RE: Mail Control Number 593105

In response to your letter requesting additional information related to our license termination request for NRC License No. 24-35094-01 we have addressed the eight (8) stated deficiencies in narrative form below and have attached requested documents to this letter.

From: Seymour, Michael <MichaelSeymour@viracor-eurofins.com>
Sent: Thursday, May 11, 2017 3:09 PM
To: Tran, Frank
Subject: [External_Sender] RE: Request for additional information regarding NRC License NO. 24-35094-01
Attachments: Response to NRC letter 4212017.pdf
Importance: High

From: Tran, Frank [mailto:Frank.Tran@nrc.gov]
Sent: Thursday, March 02, 2017 11:18 AM
To: Seymour, Michael
Subject: Request for additional information regarding NRC License NO. 24-35094-01

Attachment 1.

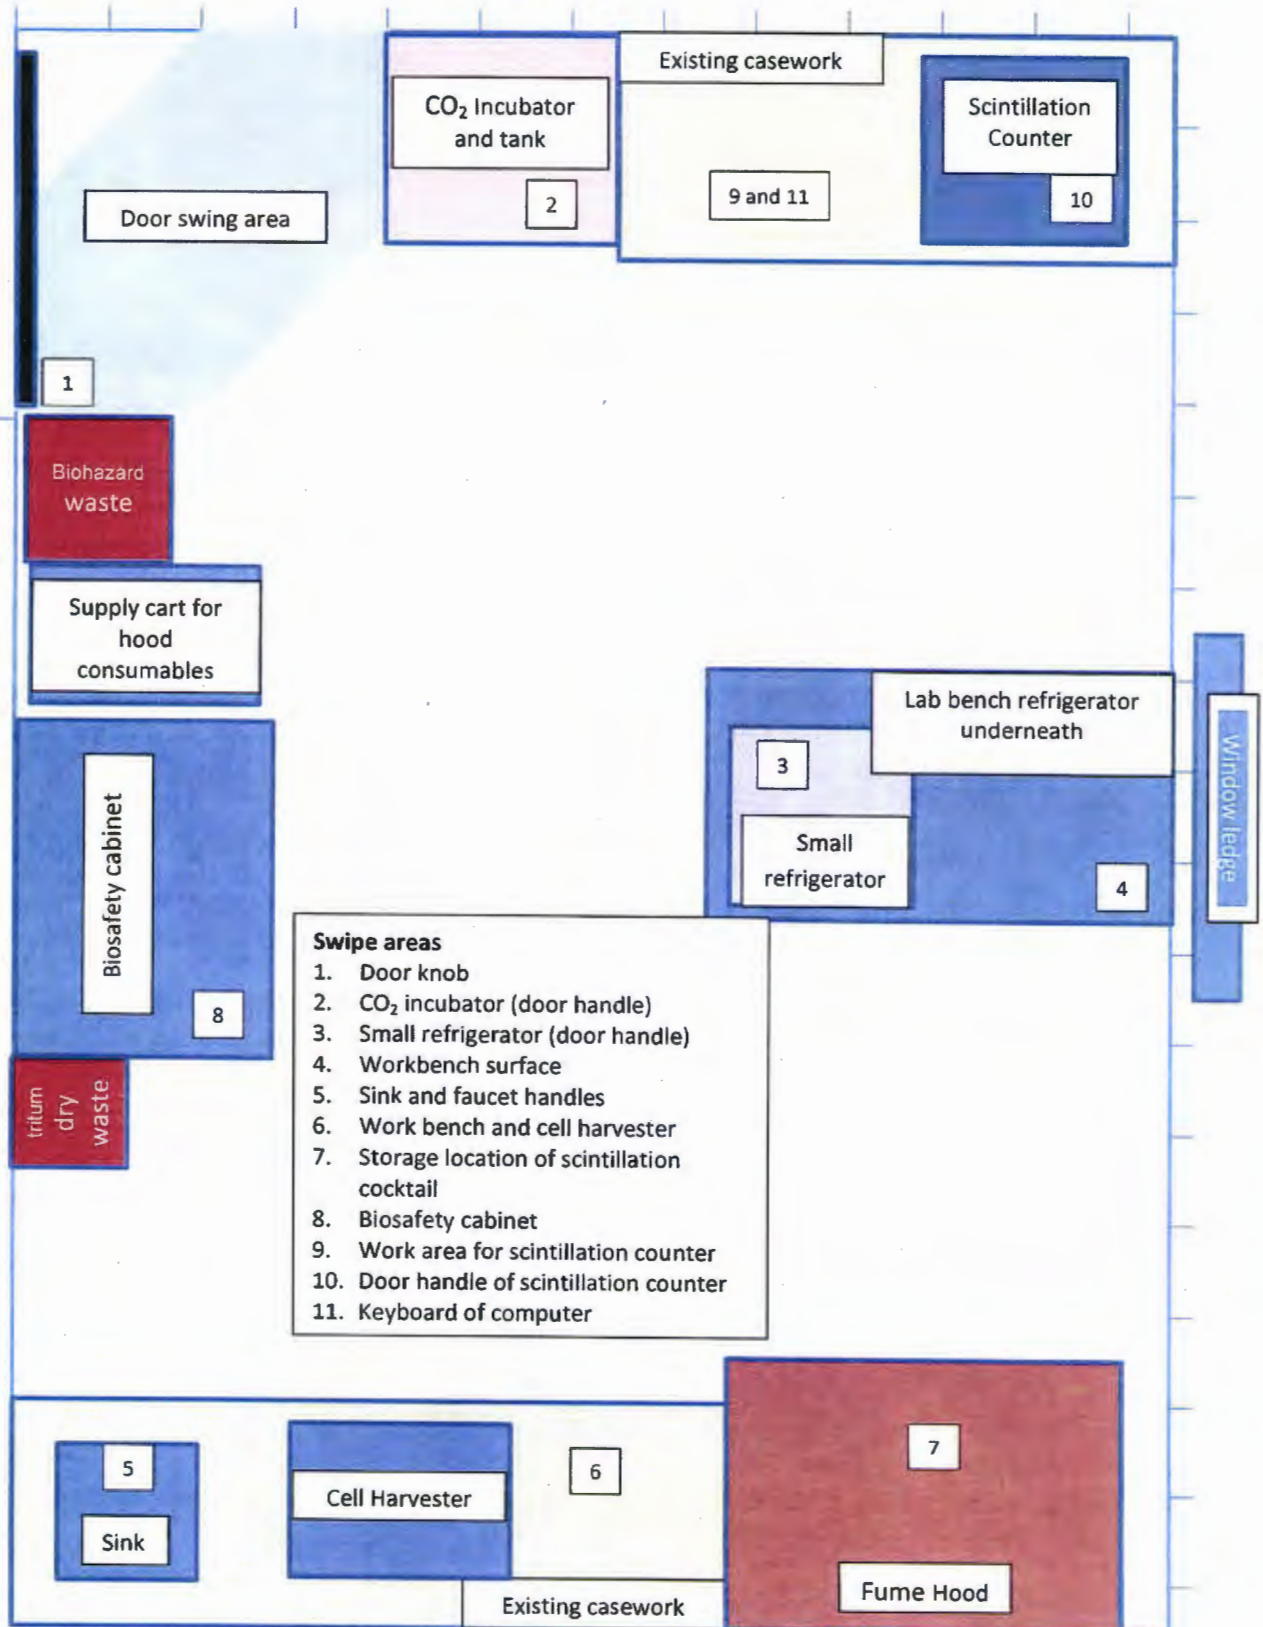
- a) A history of all radionuclides used at your old facility.
- b) A diagram of your old facility with survey and wipe test results keyed to specific locations. Please record your survey results using the appropriate units as described in 10 CFR 30.36 (j) (2) (i), "Report levels of gamma radiation in units of millisieverts (microroentgen) per hour at one meter from surfaces,

and report levels of radioactivity, including alpha and beta, in units of megabecquerels (disintegrations per minute or microcuries) per 100 square centimeters—removable and fixed—for surfaces, megabecquerels (microcuries) per milliliter for water, and becquerels (picocuries) per gram for solids such as soils or concrete”.

- 2) A diagram of the old workspace (**Attachment 1.**) is included with this letter, as are the survey results (**Attachment 2.**). The Scintillation Counter used to analyze the samples does not provide results in disintegrations per time unit; instead results are reported in Counts per Minute (CPM). A search of the instrument literature did not reveal a formula that would convert CPM into disintegrations per time unit format.
